STAFF REPORT FOR THE CLARKSBURG TOWN CENTER

PROJECT PLAN NO. 9-94004

CLARKSBURG TOWN CENTER

March 22, 1995

FIGURE 19

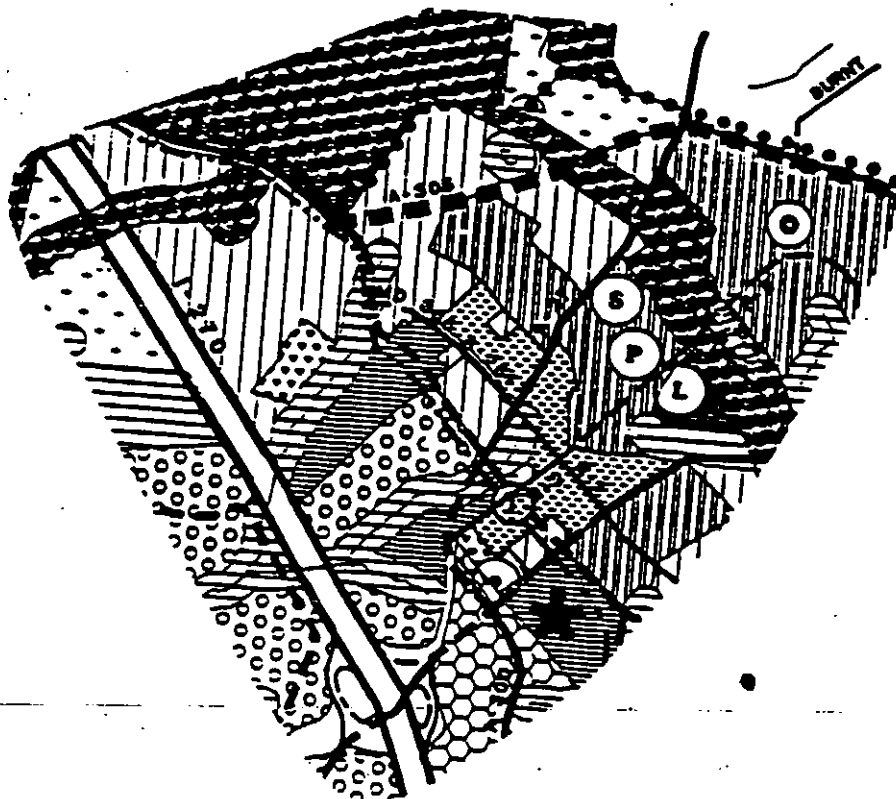
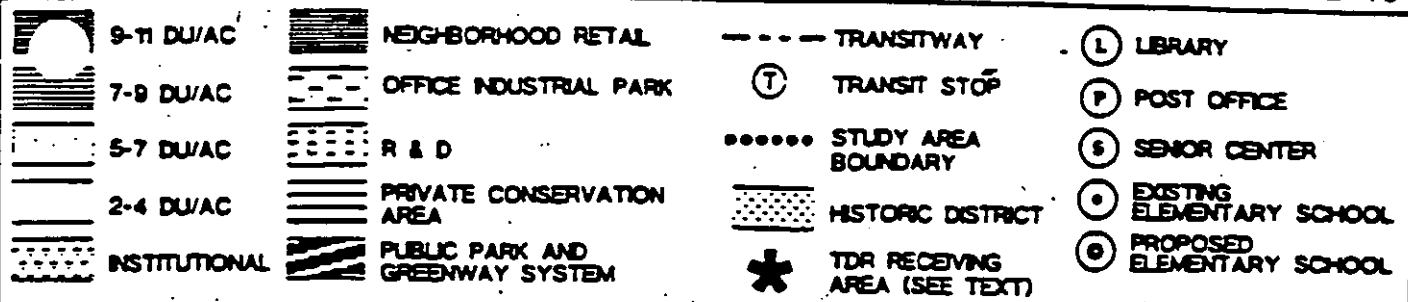
- A. Submit for review prior to Planning Board hearing on the preliminary plan submission:
 1. Improved plans for stormwater management (SWM) and grading in the commercial area that reduce stream buffer encroachment. As part of this, submit an alternative plan for review that shows all road grading, SWM and associated grading entirely outside of the stream buffer, to evaluate the impacts on site design and SWM effectiveness. Also submit calculations for the proposed in-stream dry pond on the commercial side showing the frequency and extent of inundation in the ponding area.

2. Plan for the proposed SWM facilities and roads near or in stream buffer, and associated grading, with indication of where tree planting is permitted.

3. A staging plan for SWM with the extent of each proposed phase of development and the order in which they will be built.
 4. A preliminary forest conservation plan reflecting the revised layout. At the first site plan review, applicant should present reforestation/afforestation plans for the whole site and plant as much as possible during the first construction phase to meet a Special Protection Area recommendation for quickly establishing forest.
